TYSON'S CORNER II MULTI-FAMILY

SUMMARY

Owner Lake Nona Holdings, LLC	Property Location: The subject property is located east of Narcoossee Road, north of Tyson Road and south of Lake Whippoorwill. (28.21 acres, District 1).	Staff's Recommendation: Approval subject to the conditions in the staff report.
Applicant Robert Paymayesh PE Group, LLC	Applicant's Request: 1. Specific Parcel Master Plan (SPMP) approval for 284 multi-family units.	
Project Planner Michelle Beamon, AICP		
Updated: January 8, 2016

MASTER PLAN ANALYSIS

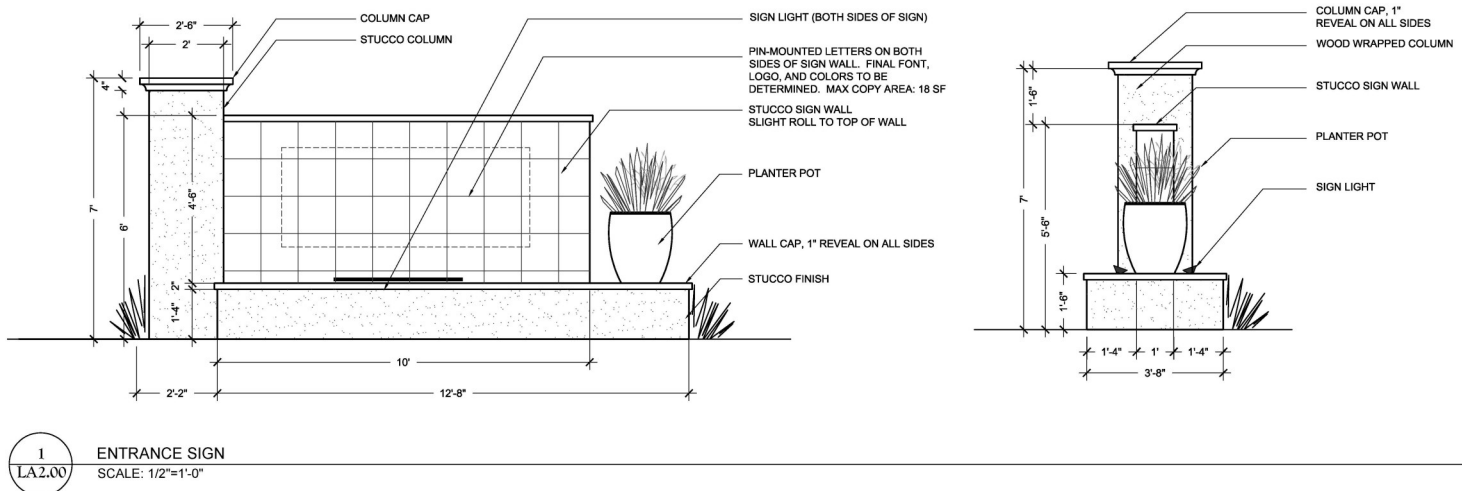
The setbacks for the multifamily buildings are unique to this site. The multifamily buildings front on internal streets and have street sides on Street A. Due to the street cross section and additional landscaping area, the street side setback is 25' which is larger than the 0' as required by the AC-1 zoning district (the Southeast Sector Plan does not have a street side setback for the Village Center). The front setback from the internal drives is also a minimum of 25'.

The setbacks for the multifamily buildings are street side setback is 25' and the front setback from the internal drives a minimum of 25'.

PROPOSED SITE PLAN

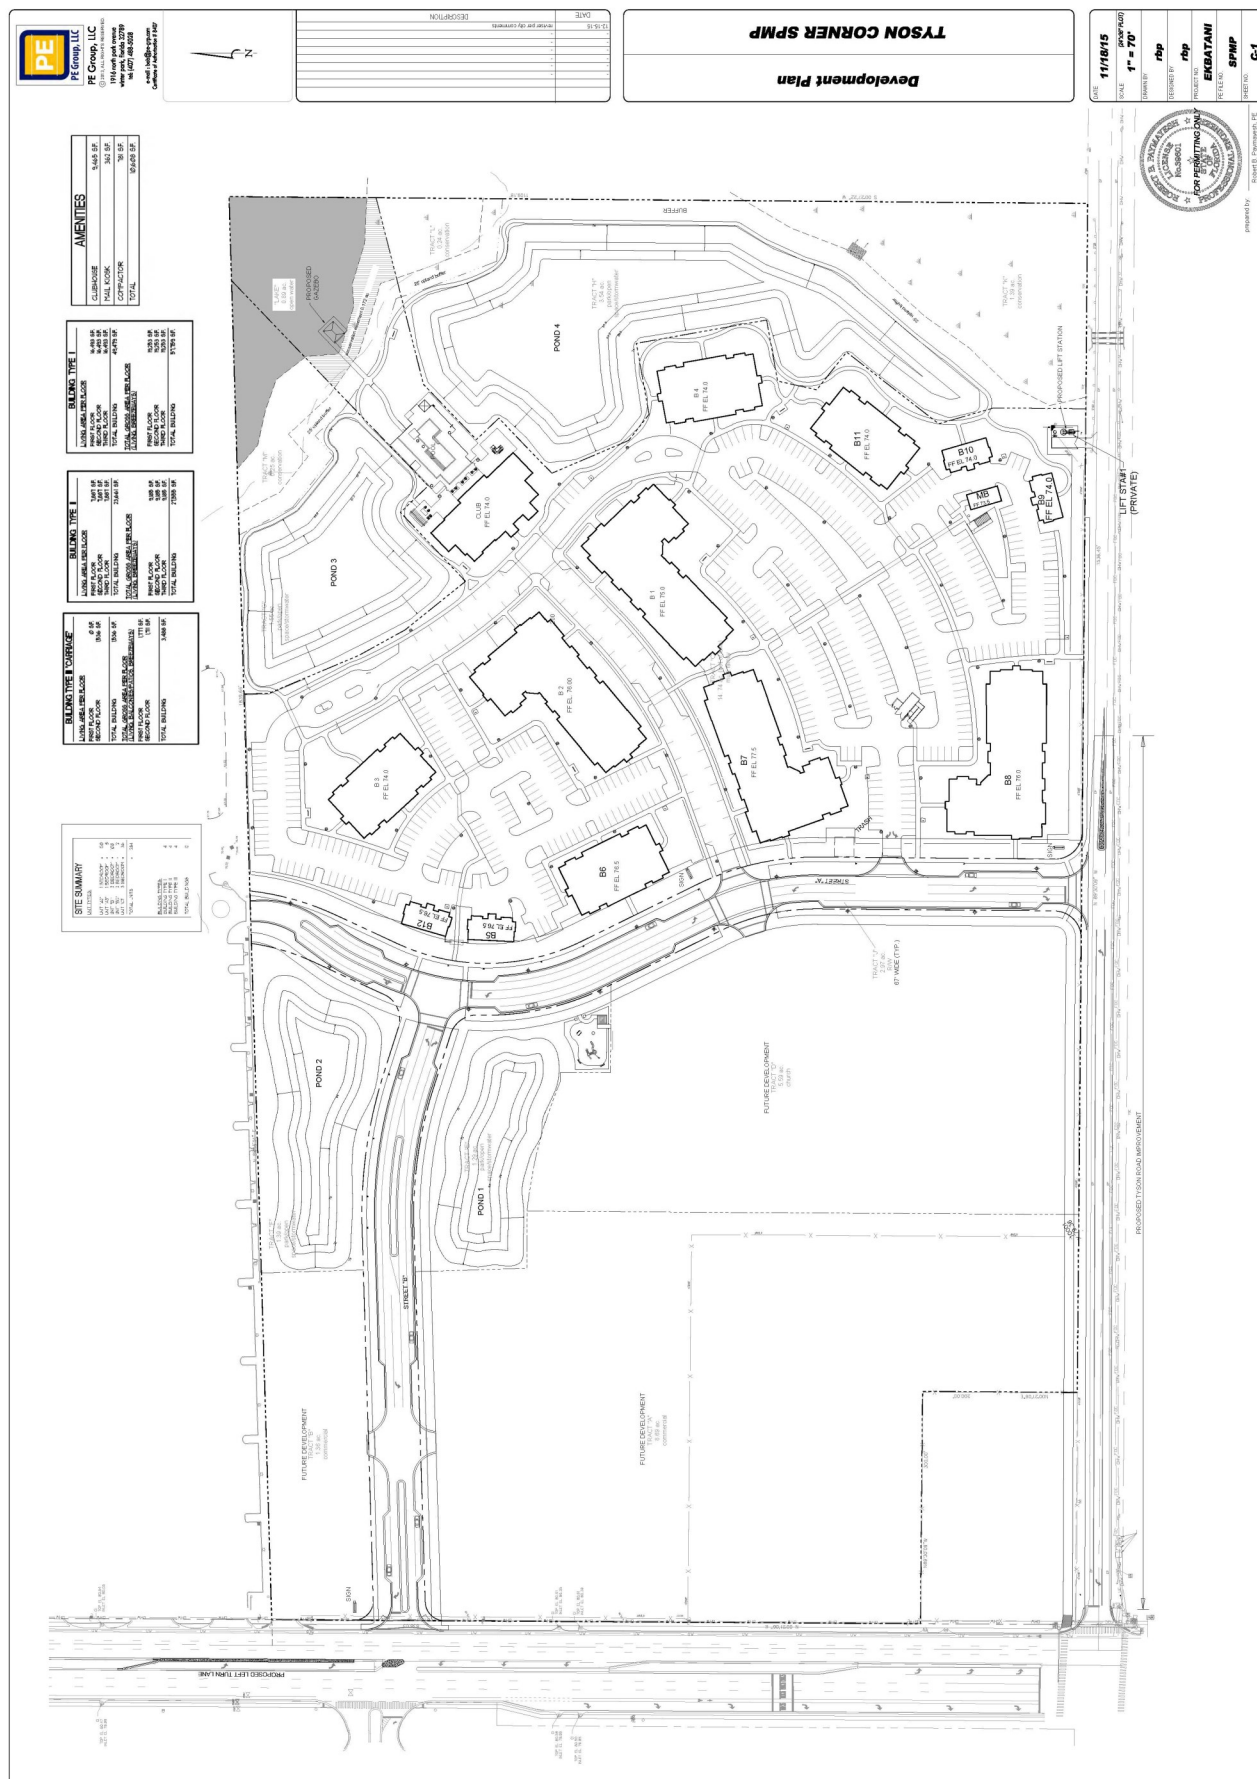
The Village Center -residential blocks requires 1.5 spaces per unit, this yields 426 spaces for the 284 units. The site plan is providing 512 parking spaces.

The Village Center -residential blocks requires 1.5 spaces per unit, this yields 426 spaces for the 284 units. The site plan is providing 512 parking spaces.

PROPOSED STREET CROSS SECTIONS

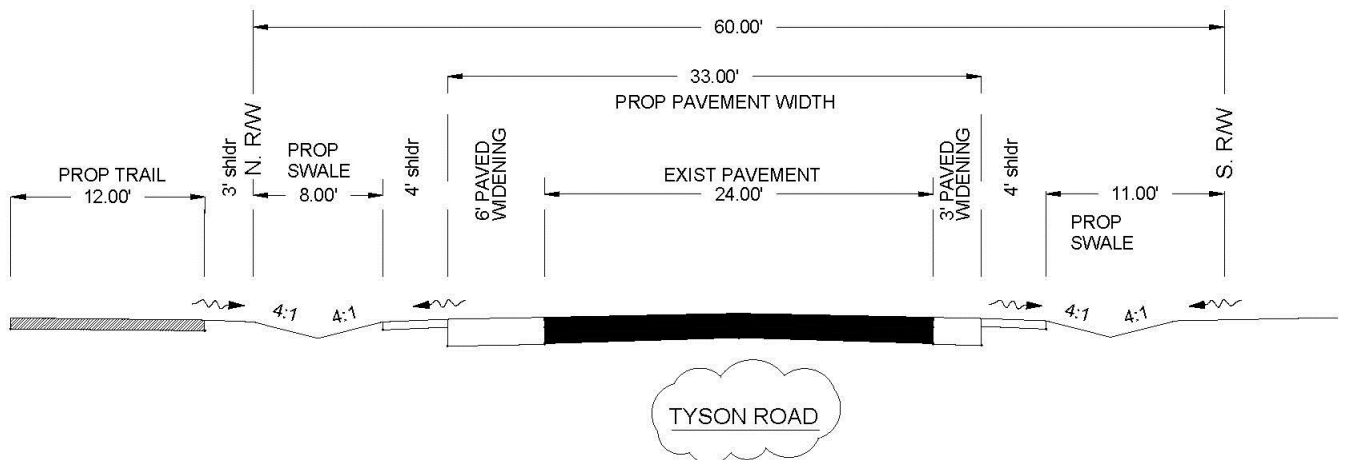
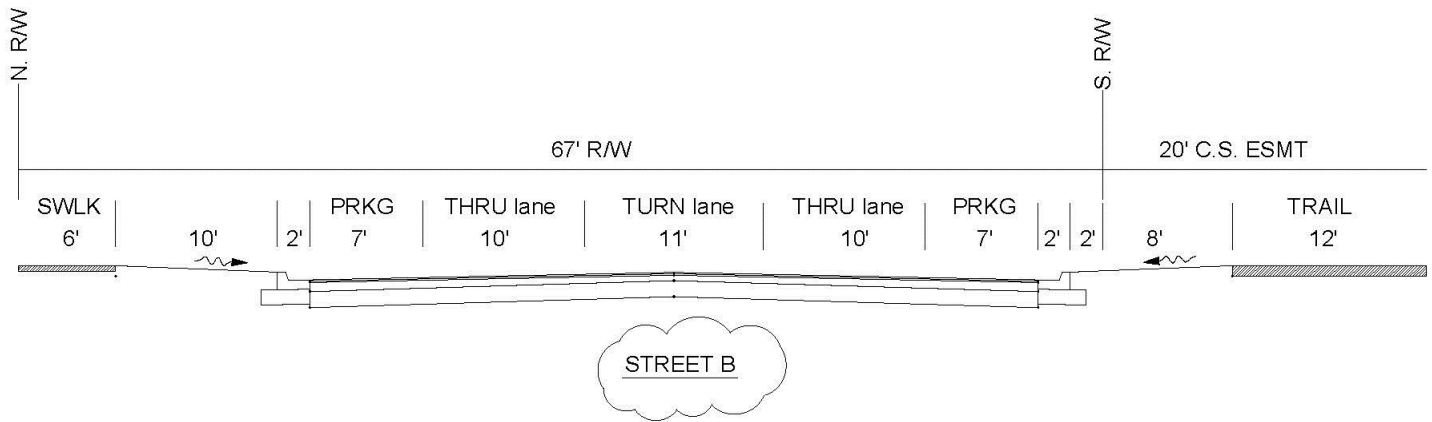
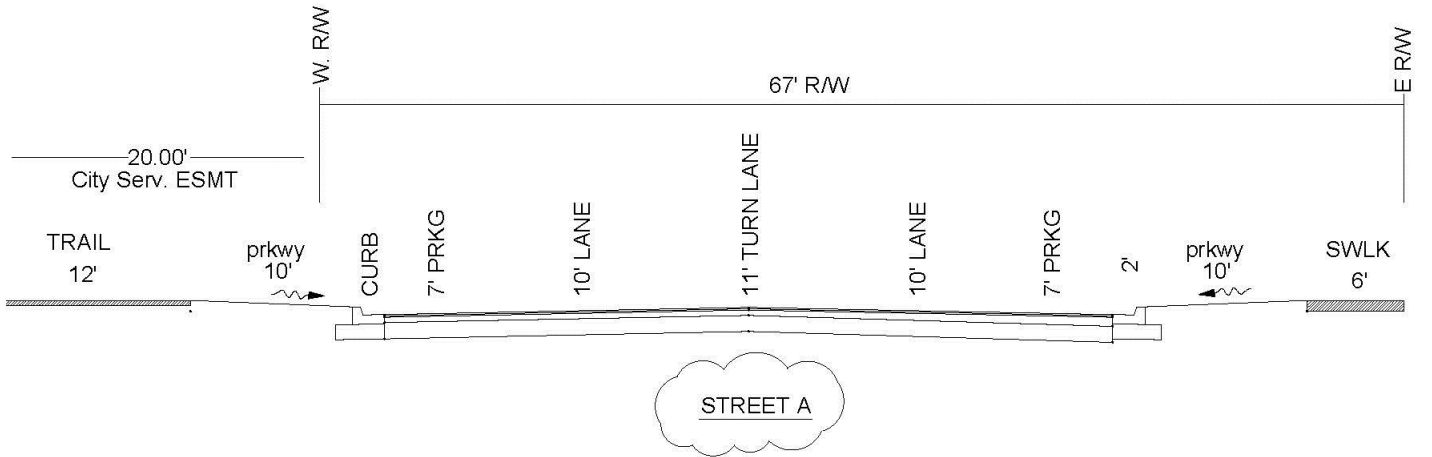
Typical cross-sections have been developed for each type of street within Southeast Orlando. Each cross section details lane width, medians, bicycle lanes, parking, sidewalks, landscape areas, drainage (rural roadways), and required right-of-way. Cross sections may be modified to accommodate special circumstances. Street A and Street B within this project are two way arterial as defined by Figure 68-L. This cross section, as displayed on page 11 is being adjusted to have a large multiuse path instead of on street bike lanes.

Note: The turn lanes in Street A and Street B are not continuous turn lanes throughout the site. Periodically medians are present, as shown on the site plan and landscape plans.

Street A & B shall follow the design criteria approved in ZON2015-00008.

EXCERPT OF PROPOSED SITE PLAN EXHIBIT

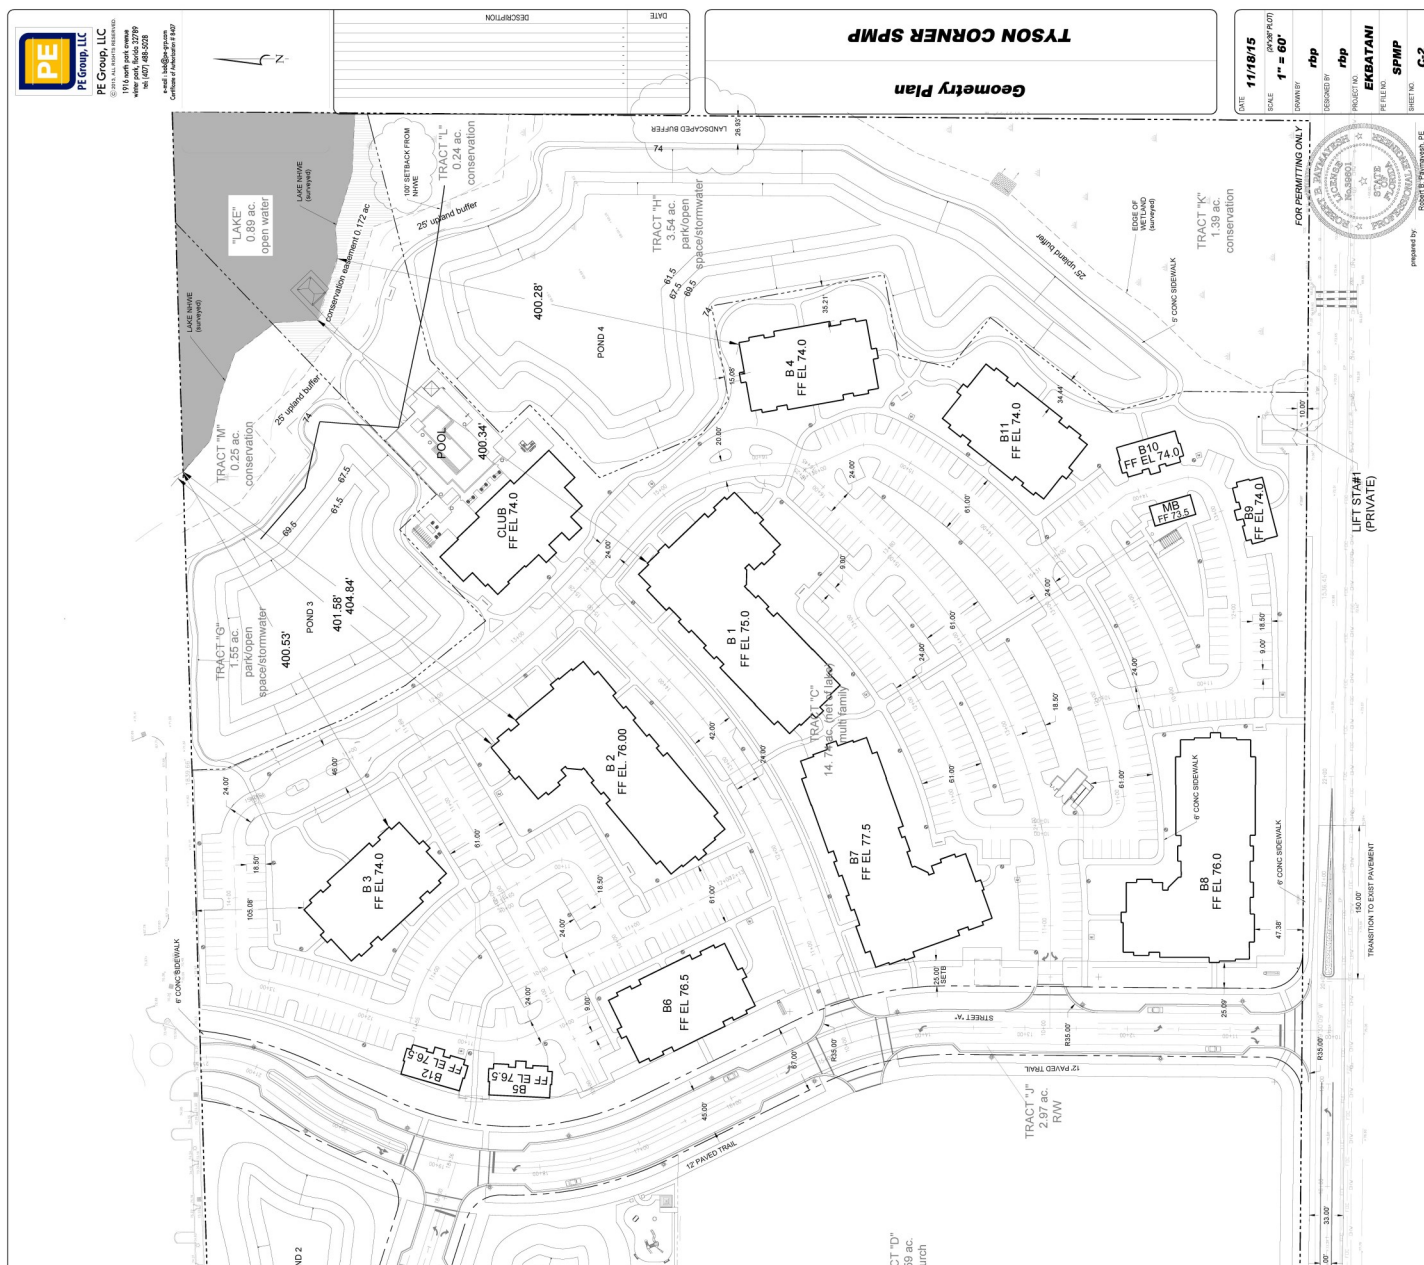
HIGHLIGHTING DISTANCES FROM LAKE WHIPPORWILL

The height limit within 400 feet of the Lake Whipoorwill mean high water line shall not exceed two stories. In all other areas, the maximum height shall not exceed four stories.
